THE ROYAL BOROUGH OF KENSINGTON AND CHELSEA

PP 101/1529

21 Eldon Road, W8

**TOWN & COUNTRY PLANNING ACT 1990
APPEAL BY RICHARD PEASE
SITE AT 21 ELDON RD, LONDON, W8 5PT**

SECTION C-C

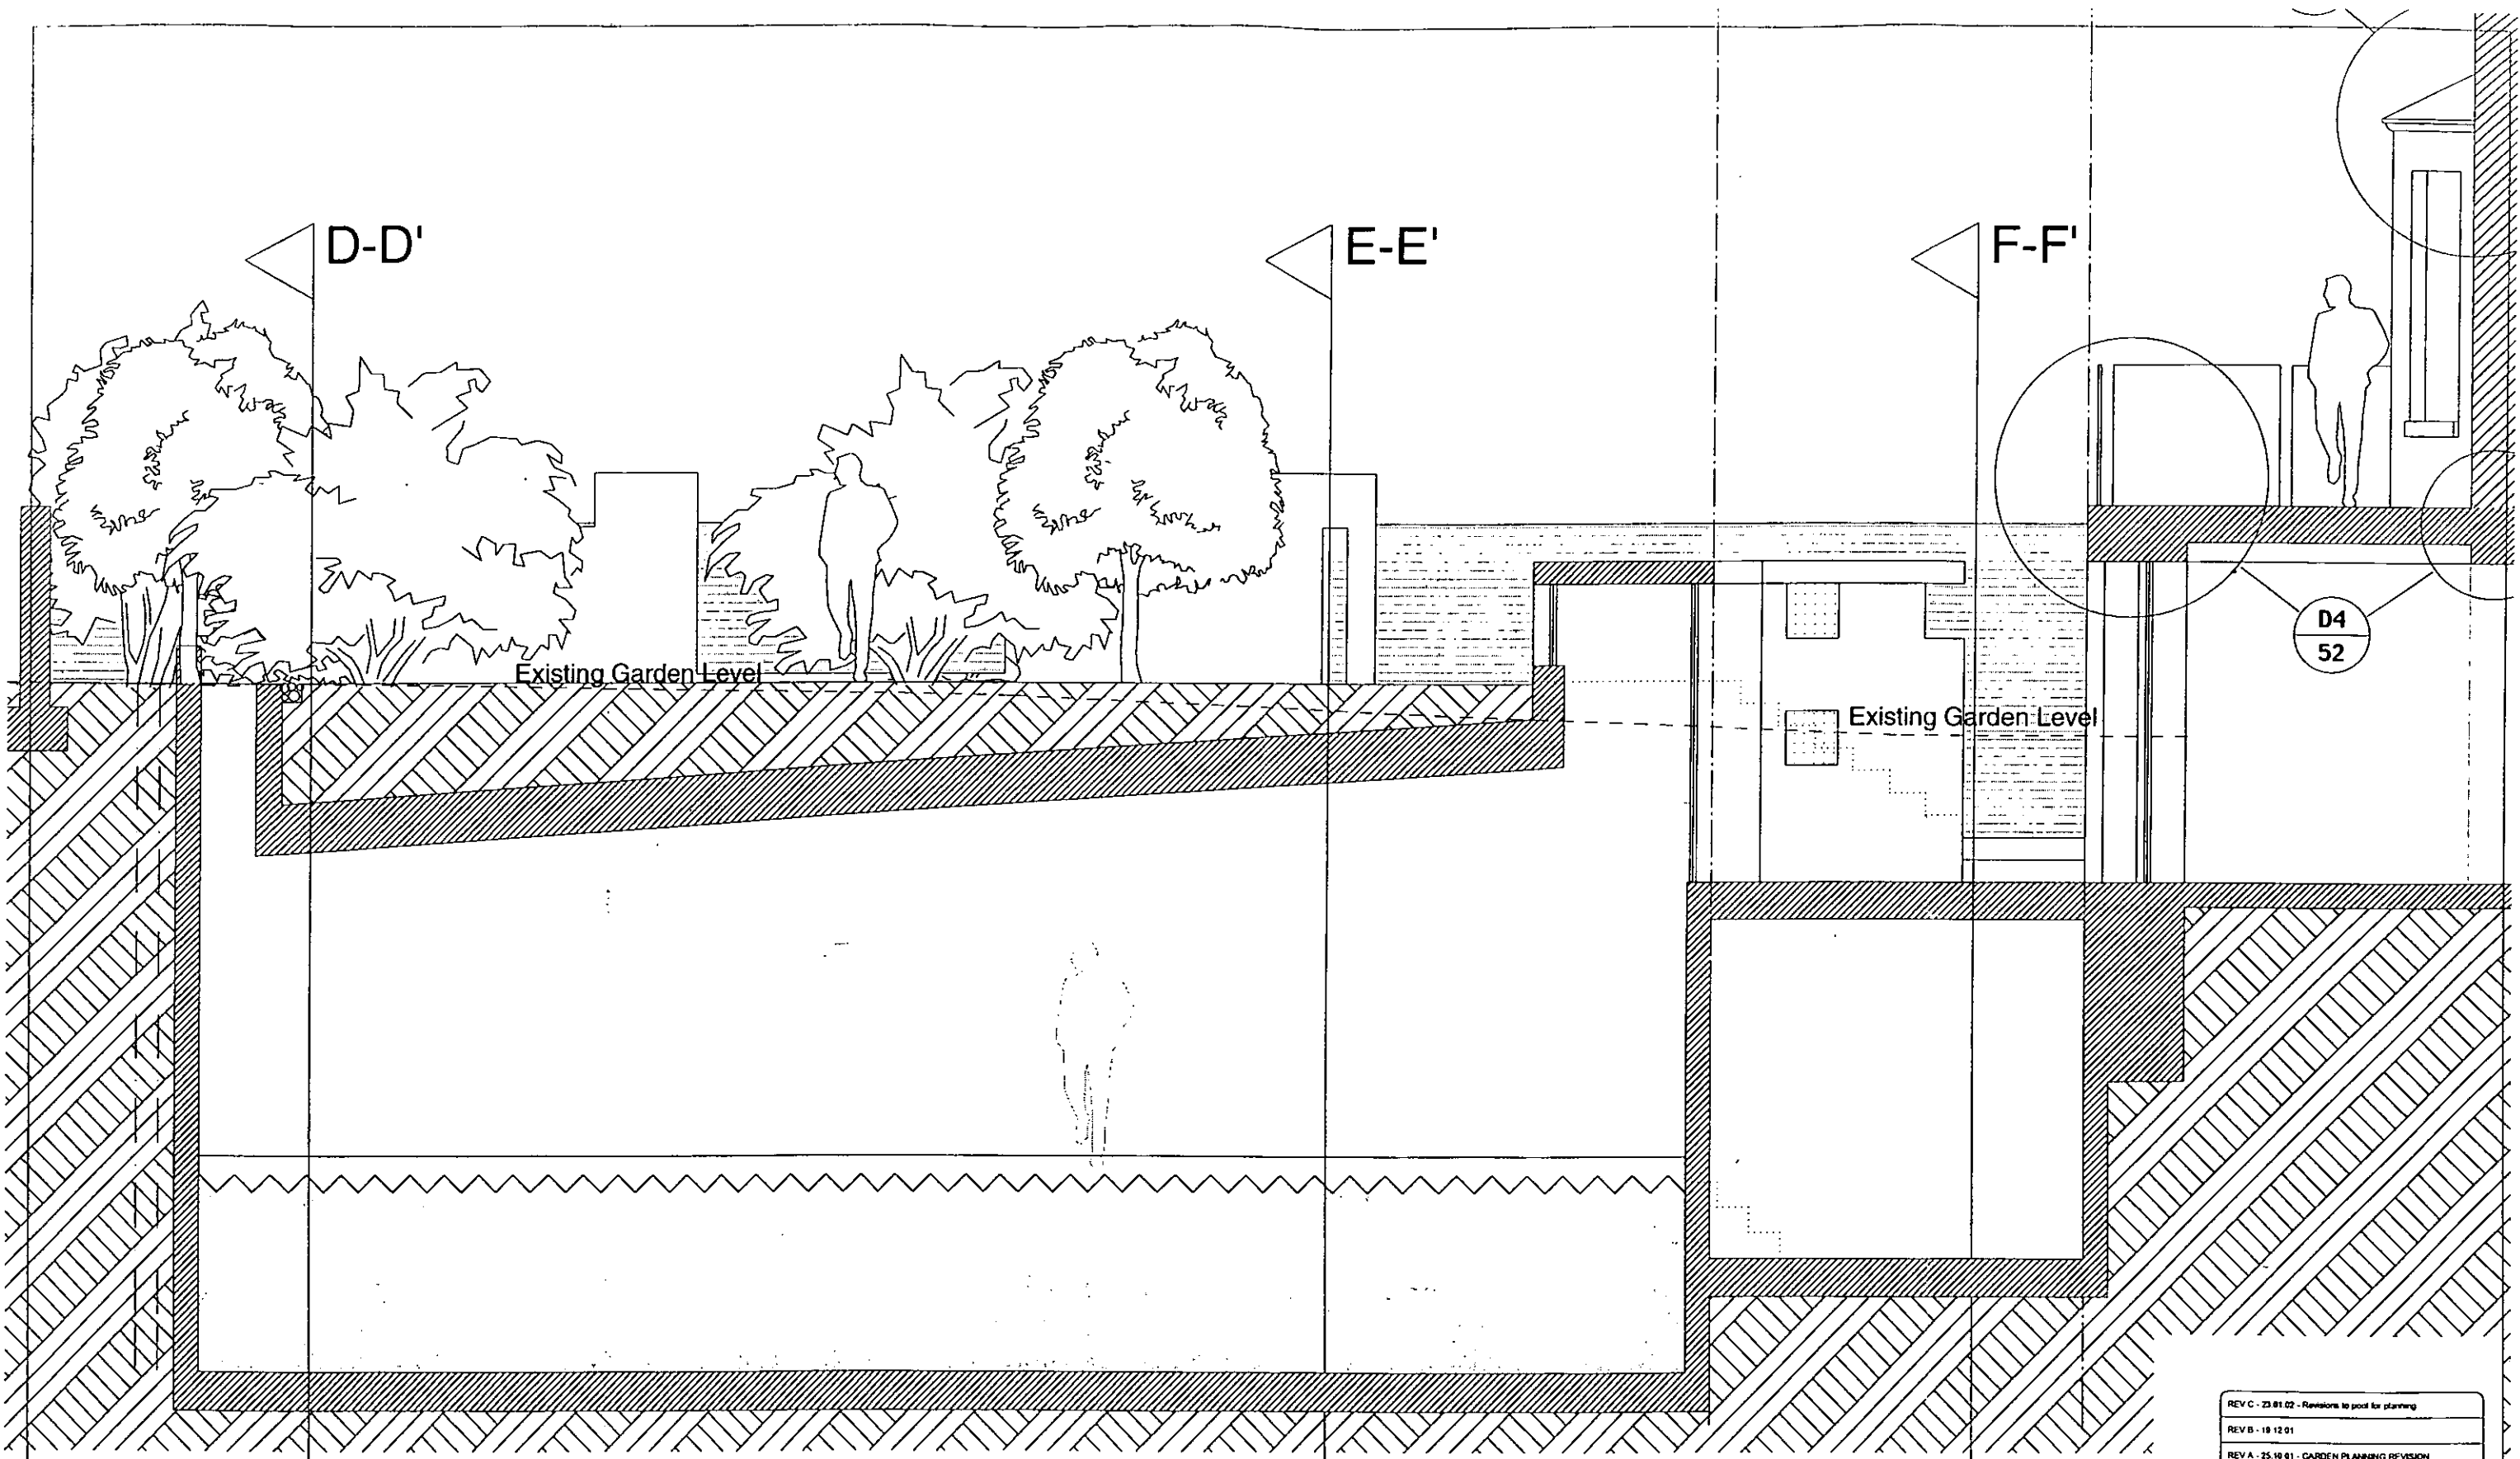
On drawing 01/15/L(24)(Revision G) submitted with your letter, it shows a change to the depth of soil provided in the rear garden above the submerged room as approved in PP/02/722. Instead of a soil depth of a metre throughout, the soil decreases from 1.423 metres at the rear of the site to 0.423 metres next to the courtyard. You state that you do not wish to implement the planning permission for the construction of an underground swimming pool in the rear garden as approved on appeal on 18th September 2002 (APP/K5600/A/02/1088164), however you wish to use the soil depth approved in this permission as is shown in drawing 01/15/L(24)(Revision G). On the basis of this drawing, it is my opinion that this is acceptable.

SECTION C-C

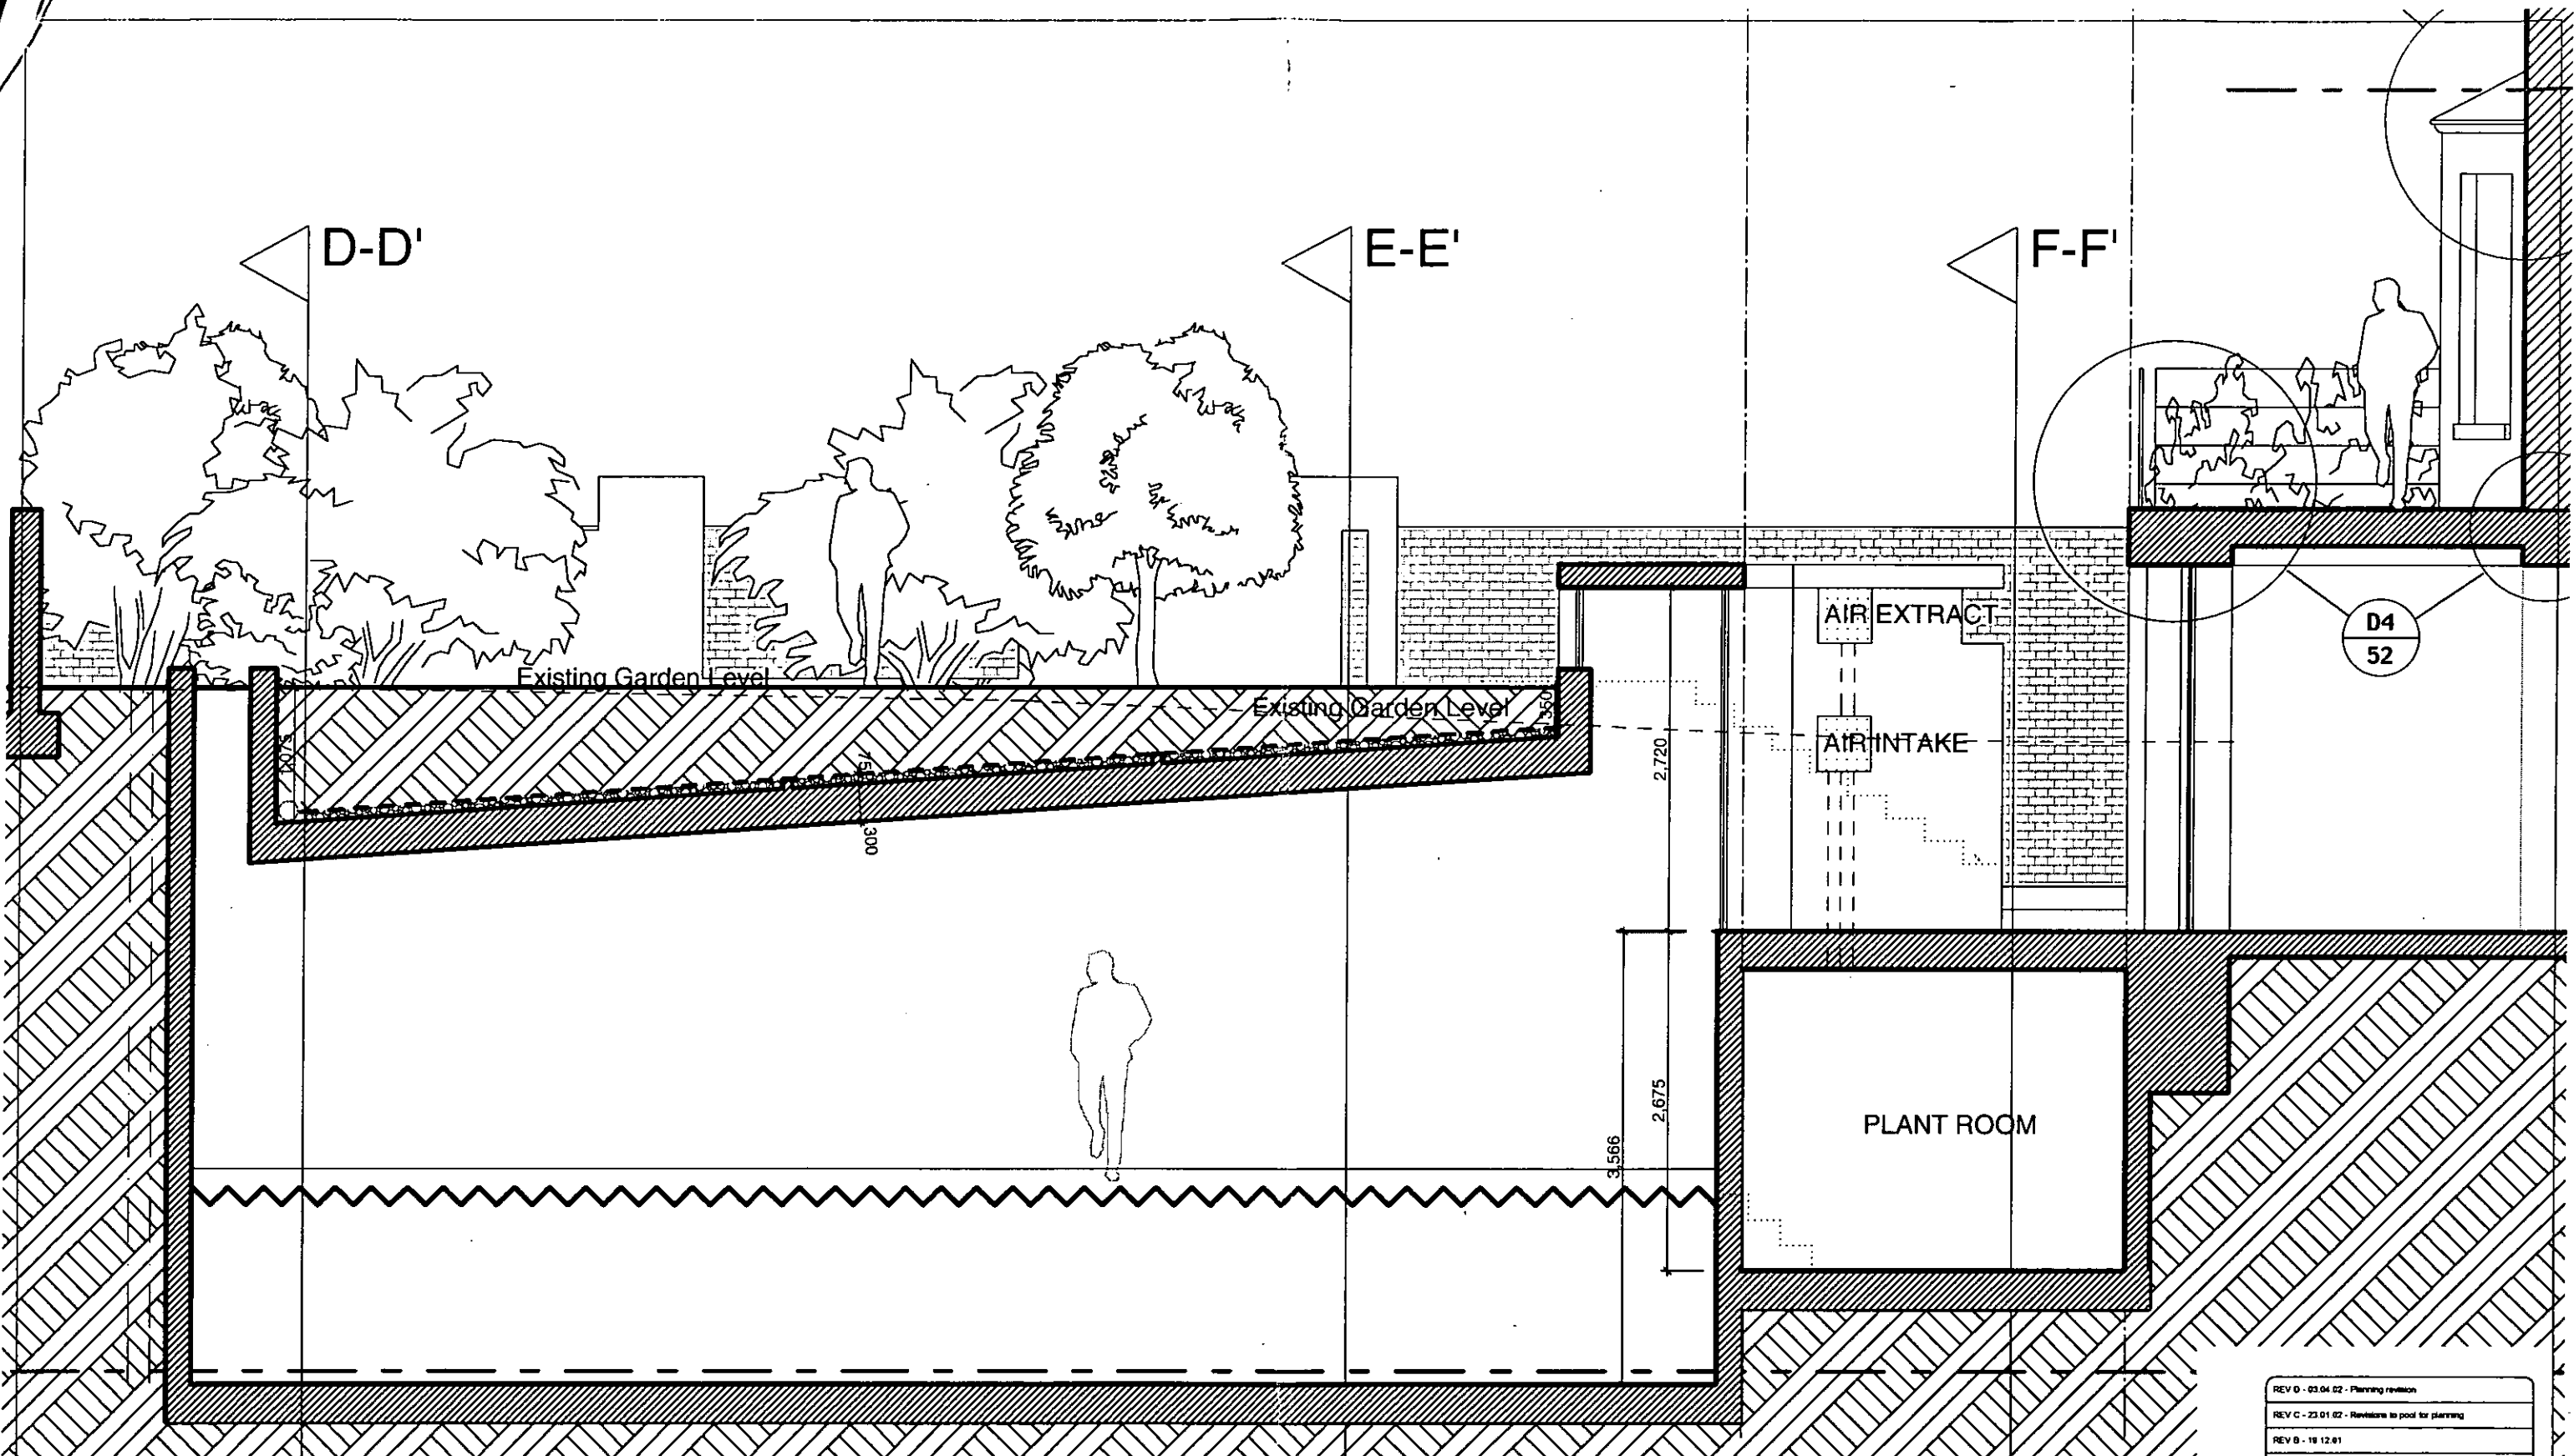
The applicants have supplied drawing no.01/15/L(27) (RevA) which indicates the finished garden level of the application site in relation to the two adjoining residential properties. It appears that the garden level will be raised 450mm in relation to the adjoining gardens once the pool has been completed. With the exception of the inflow/outflow vents it is considered there will be no impact on visual amenity as a result of the proposed pool. The applicants have advised that the proposed pool ventilation and filtration system will be fitted with a supplementary ozone system, Prozone, which reduces the required chlorine needed to maintain the pool to a level which is less than found in tap water. It is accepted that this will not result in any detectable chemical odours which will adversely impact on the adjoining properties. However, there may be an impact with regard to noise generated.
